PROPOSED LIQUOR STORE DEVELOPMENT

ELEVATIONS
SCALE - 1:100
PROPOSED LIQUOR STORE DEVELOPMENT

Comments from 18 March 2008 Council Report

OVERALL SITE PLAN

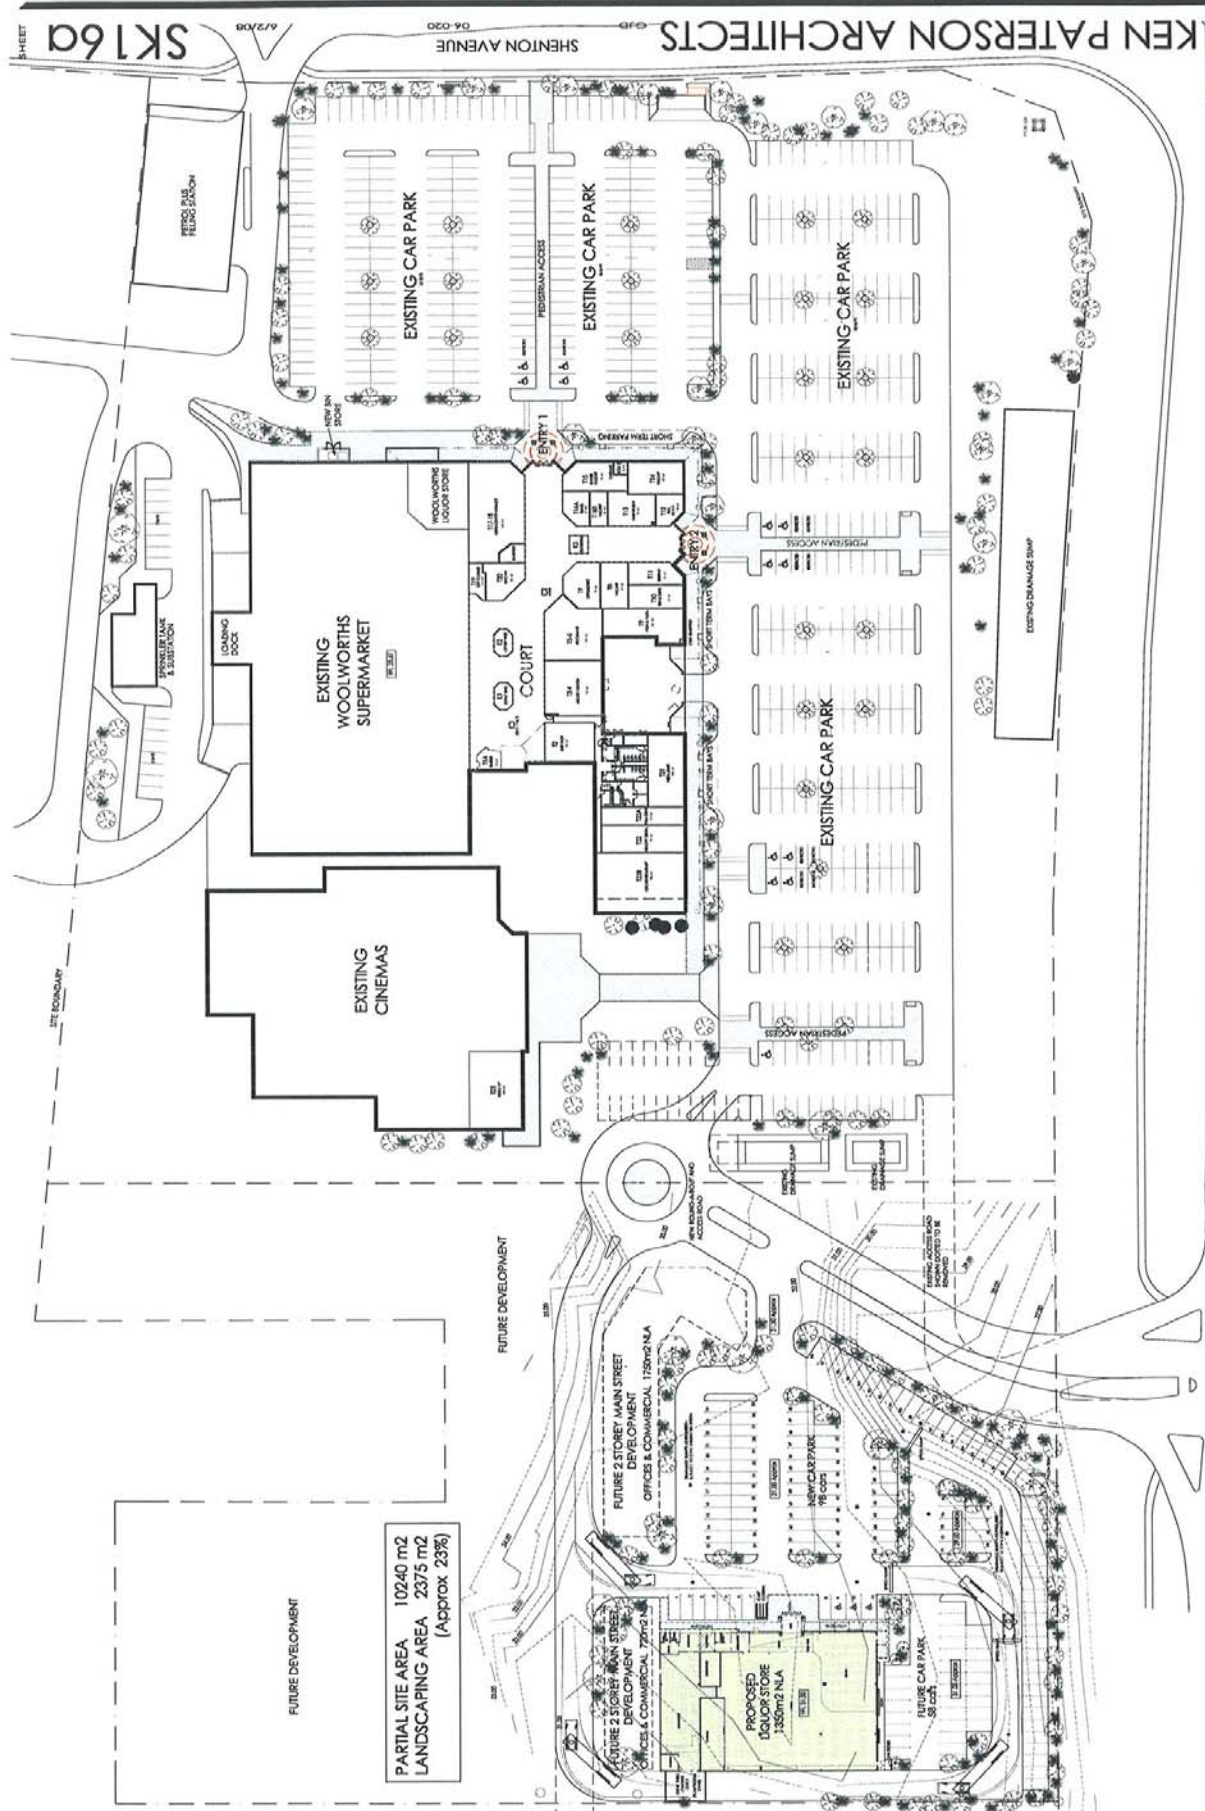
The proposed setbacks from the liquor store to the eastern and southern boundaries are 14 metres and 60 metres respectively. Although this does not comply with the requirements of the Structure Plan the liquor store is proposed to be setback such that a future Main Street development can be built along the eastern lot boundary. The liquor store has been purposely located behind the future Main Street development due to the nature of the goods sold and the need to restrict their display.

A car park is proposed along the southern boundary of the lot, which does not comply with the Urban Edge requirement of the Structure Plan. However, the proposed car park along this boundary is considered to be acceptable as it is opposite an area designated as a Non Urban Edge and is also shown on the Concept Plan of the Structure Plan as a car park.

The design of the proposed car park has been amended so that the future office/commercial building addresses the south western corner and a portion of the southern boundary, rather than the eastern boundary only. It is considered that this variation is acceptable and should be supported.

The Structure Plan states that a continuous 3 metre wide footpath is to be provided along building edges, other than where a loading bay abuts the building. Under this requirement, the southern and western sides of the building should have 3 metre wide footpaths along them. However, the footpath on the southern side is 3 metres surrounding the entrance, narrowing to 2.5 metres for the remainder of the building, and the footpath along the western boundary is 2.5 metres narrowing to 1.5 metres in width. This is considered to be acceptable as the entrances to the building are surrounded by wider footpaths allowing sufficient space for pedestrians to access the building safely. The proposed footpath width complies with AS1428.1 2001 which states that walkways, ramps and landings shall be not less than 1 metre in width to provide for disabled access. It is therefore recommended that Council support this variation as the reduced footpath width will not have a negative impact on the proposed development.

The proposed liquor store requires the provision of 95 car parking bays based on a Net Lettable Area (NLA) of 1350m². A total of 98 car parking bays are provided for the proposed development. The proposed number of bays therefore complies with the requirements of DPS2.

The Structure Plan states that car park landscaping shall be in accordance with the requirements of DPS2. DPS2 requires that where a car park abuts a street, a 3 metre wide landscaping strip shall be developed and maintained along all street boundaries. The development proposes a 2.5 metre wide landscaping strip along the access road and a 2 metre wide landscaping strip along Marmion Avenue. It is recommended that a condition be included on the proposal for a minimum 3 metre wide landscaping strip along Marmion Avenue. The provision of a 2.5 metre wide landscaping along the access road is considered to be appropriate as the access road is internal and is opposite an existing drainage sump.
